**PLANNING DEPARTMENT ADMINISTRATIVE PUBLIC HEARING
SUMMIT COUNTY, UTAH
July 3, 2025**

- 1.A. **176 Main Street – Historic District Design Review** – The Applicant Proposes to Construct an Addition on a Landmark Historic Structure in the Historic Residential - 2B Zoning District. PL-25-06472.
(A) Public Hearing; (B) Action

Planning Department Staff Report

Subject: 176 Main Street
Application: PL-25-06472
Author: Meredith Covey, Planner I
Date: July 3, 2025
Type of Item: Historic District Design Review

Proposed Elevations – Doors proposed to be added are shown in blue, doors retained from existing conditions are shown in green

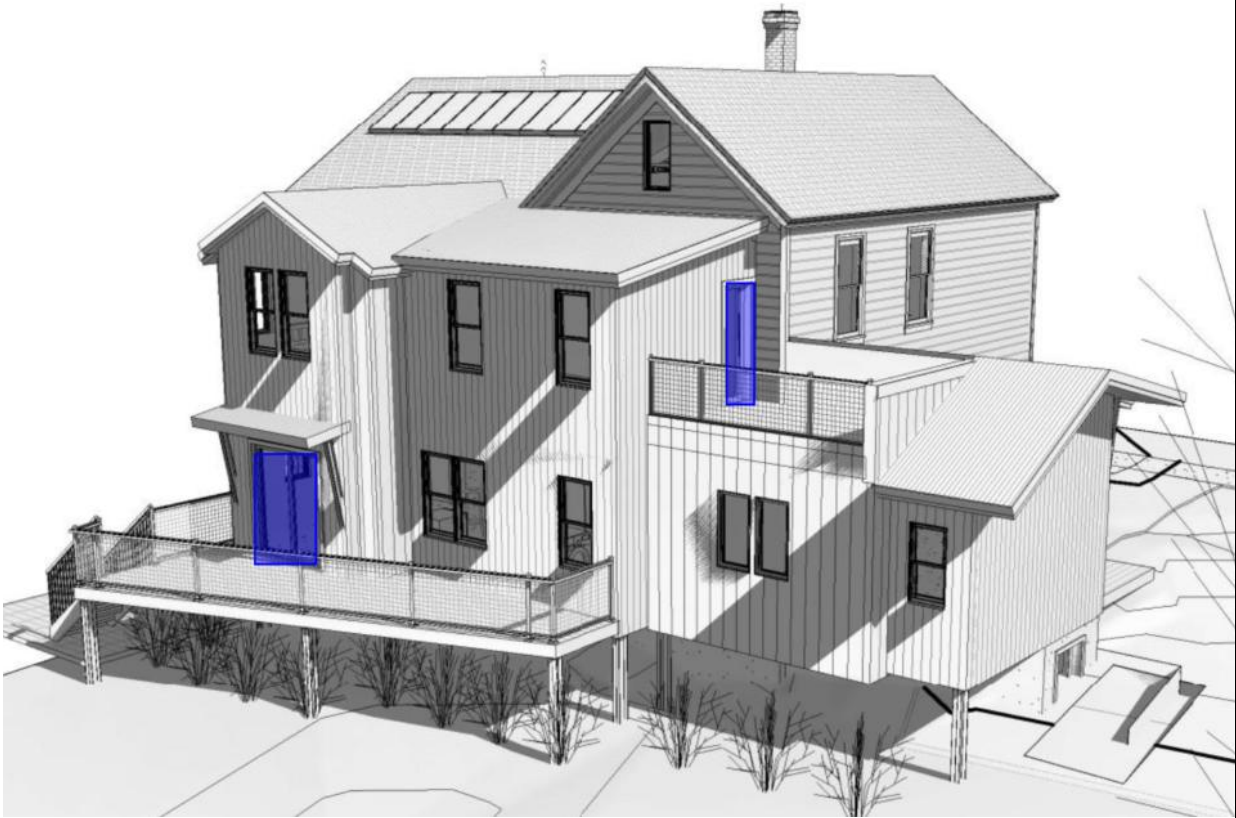
Avoid changing the position, proportions, or dimensions of historic door openings. It is not appropriate to create additional openings or remove historic openings on primary or secondary façades that are visible from the primary public right-of-way.

Condition of Approval 21 requires that the Applicant avoid changing the position, proportions, or dimensions of historic door openings and not create additional openings or remove historic openings on primary or secondary façades that are visible from the primary public right-of-way.

18. Insulation added to increase energy efficiency shall not impact the exterior dimensions of the Structure.
19. The Applicant shall avoid changing the position, proportions, or dimensions of historic door openings and shall not create additional openings or remove historic openings on primary or secondary facades that are visible from the primary public right-of-way. Replacement doors shall be similar to those seen historically in Park City. New doors shall comply with the regulations outlined in LMC § 15-13-2(B)(2)(c).

Front (west) Facade

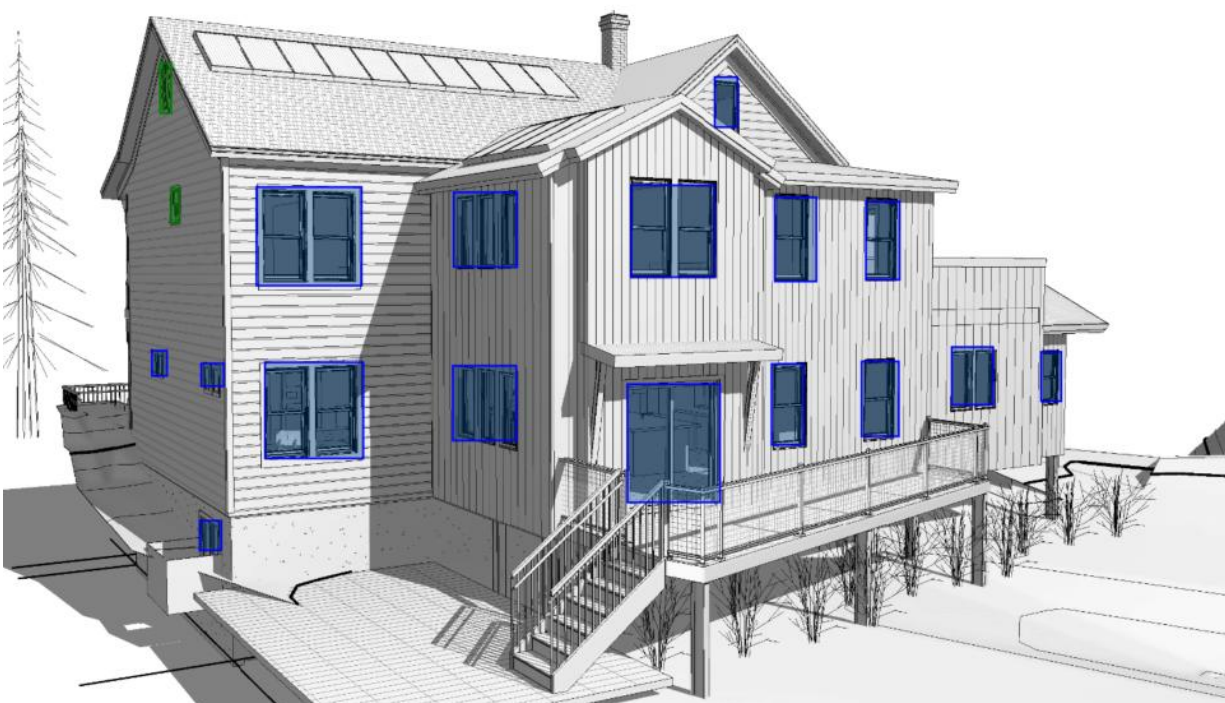
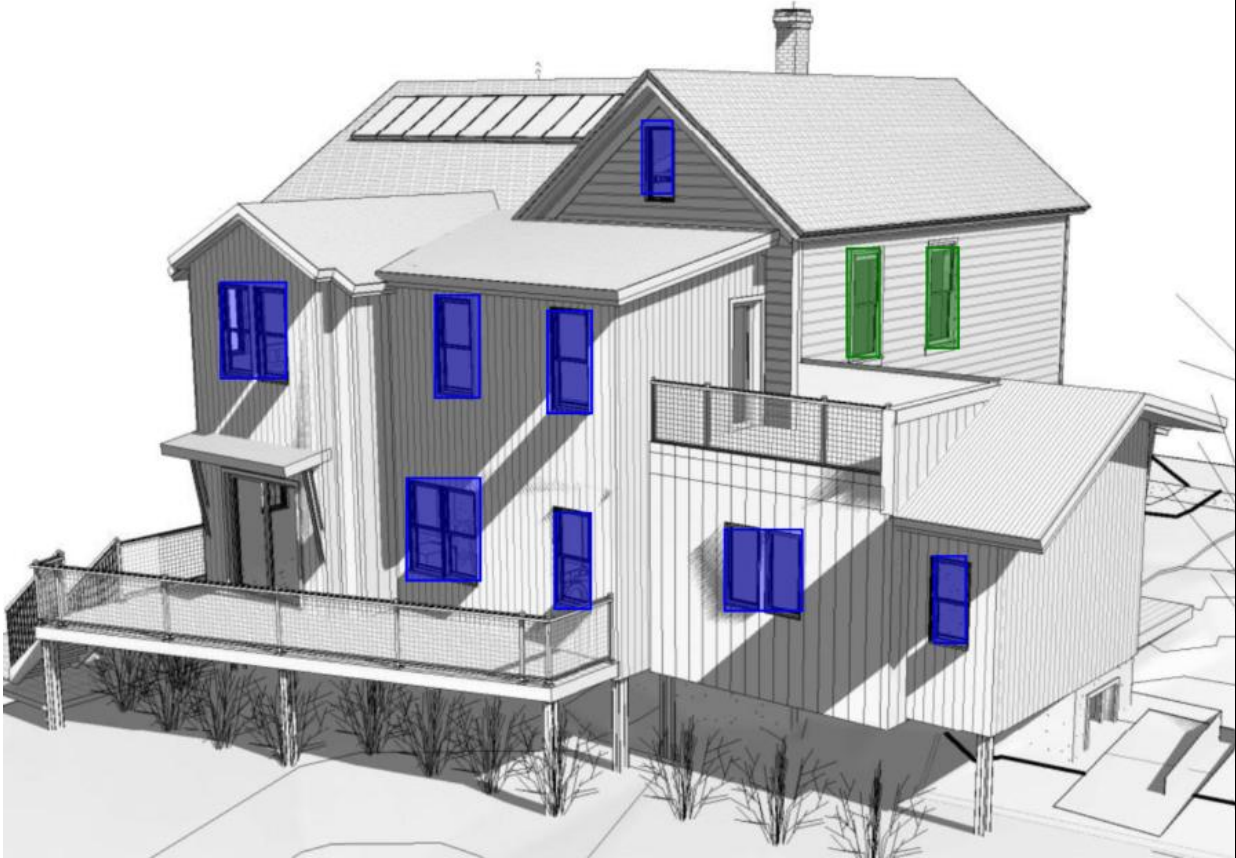
Avoid changing the position, proportions, or dimensions of historic window openings. It is not appropriate to create additional openings or remove existing historic openings on primary or secondary facades that are visible from the primary right-of-way.

The Applicant proposes to replace any windows that are not salvageable and to repair those that are able.

Condition of Approval 22 requires that the Applicant replace historic windows exactly in size, dimension, glazing pattern, depth, profile, and material.

The Applicant notes that the gabled Structure that faces east (rear façade) was likely part of an addition to the Structure though the year is unknown. The Applicant proposes to remove the doors and windows on this previous addition and replace with openings that comply with current Historic District Design Regulations.

20. The Applicant shall replace historic windows exactly, in size, dimension, glazing pattern, depth, profile, and material.
21. Replacement porch elements shall exactly match the historic elements in size, dimensions, form, profile, and material. All proposed new porches shall comply with LMC § 15-13-2(B)(2)(g).

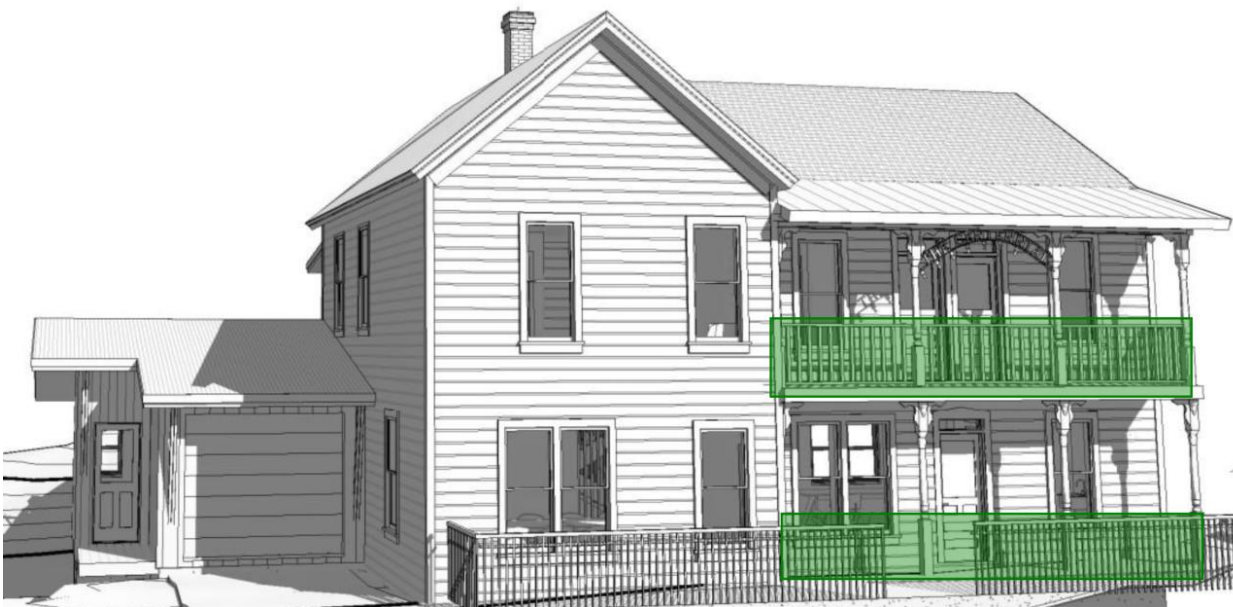
Preserve and maintain a historic porch by preserving the existing location, form, proportion, details, posts, railing, and stairs.

Repair deteriorated historic elements of the porch. Replacement porch elements are allowed only when it can be shown that the historic elements are no longer safe and/or serviceable and cannot be repaired to a safe and/or serviceable condition. Replacement elements shall exactly match the historic elements in size, dimensions, form, profile, and material.

The Applicant proposes to repair the two historic porches on the front façade, and to remove two porches on the rear façade.

replacement elements shall match the historic elements in size, dimensions, form, profile, and material, to the degree allowed by Building Code for the porch railing. All proposed new porches shall comply with LMC § 15-13-2(B)(2)(g).
<i>Proposed Elevations – Porches proposed to be added are shown in blue, porches retained from existing conditions are shown in green</i>	
 <i>Front (west) Facade</i>	
Architectural Features Preserve and maintain architectural features such as eaves, brackets, cornices, moldings, trim work, and decorative shingles. Replacement features shall exactly match the historic features in design, size, dimension, form, profile, texture, material and finish.	The Applicant proposes Reconstructing the Structure to the 1907 form. The Historic Site Form for the site suggests that the ornamental features such as the cupola, oval window, window pediments, dormers on the north roof, and architectural design elements on the front porch were added sometime between 1978 and 1983

Proposed Elevations – Existing Historic Structure proposed to remain is shown in green, proposed addition is shown in blue.

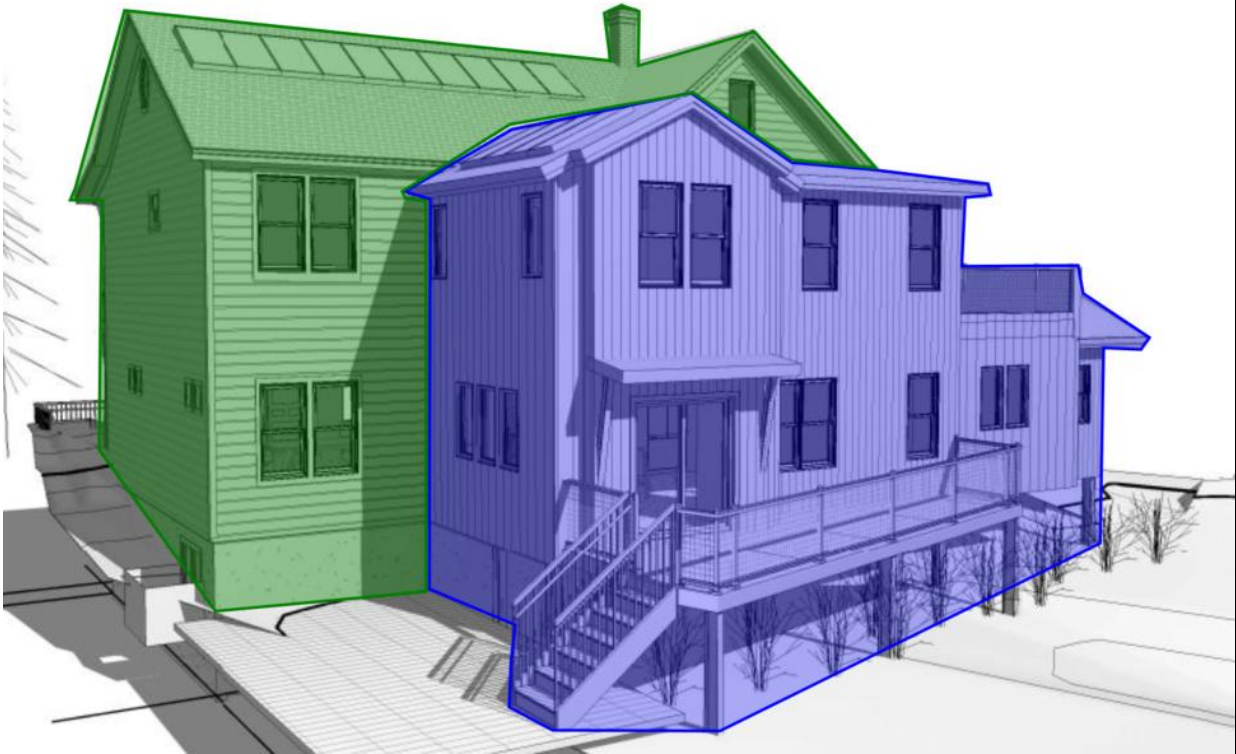
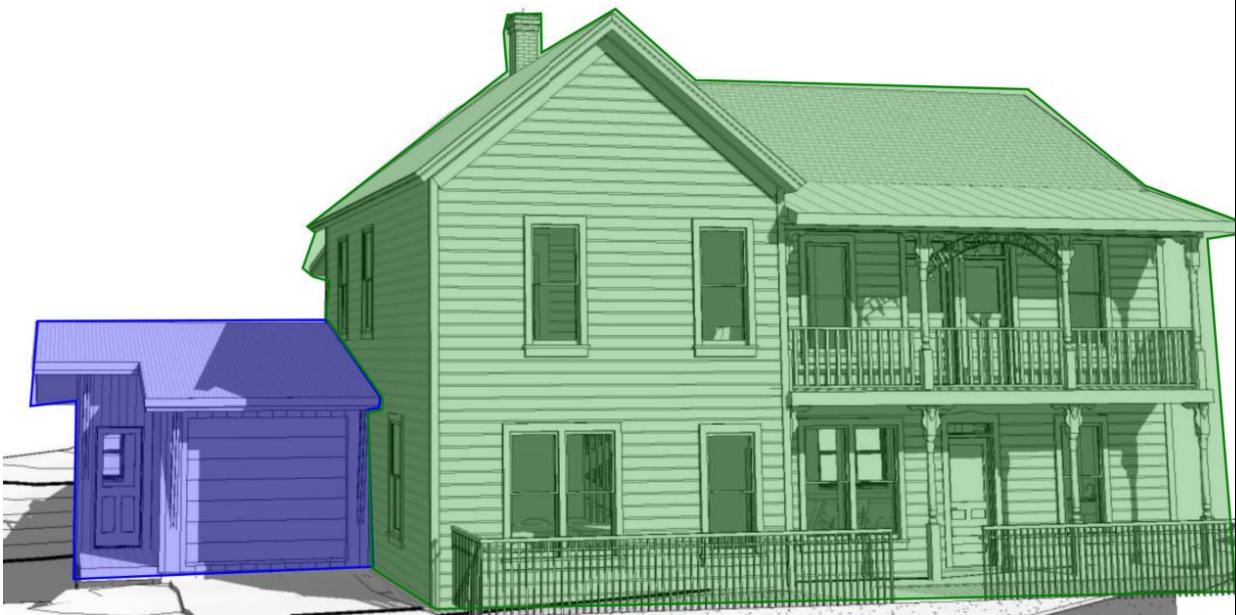
Condition of Approval 34 requires that the Applicant reduce the roof eaves to be compatible with the roof overhangs on the Historic Structure. Pursuant to LMC § 15-2.3-3(J)(6) patios not more than 30 inches above Final Grade are permitted exceptions within the Side Setback. The proposed patio is less than 30 inches above Final Grade and is compliant.
<i>Snow Release:</i> Site plans and Building designs must resolve snow release issues to the satisfaction of the Chief Building Official.	Condition of Approval recommended: Condition of Approval 35 requires the Applicant shall obtain Chief Building Official approval for proposed snow release plans for the site, pursuant to LMC § 15-2.2-3(K).

33. The Applicant shall obtain Chief Building Official approval for proposed snow release plans for the site.
34. The Applicant shall reduce the width of the roof eaves over the addition to be compatible with the overhang seen on the Historic Structure.
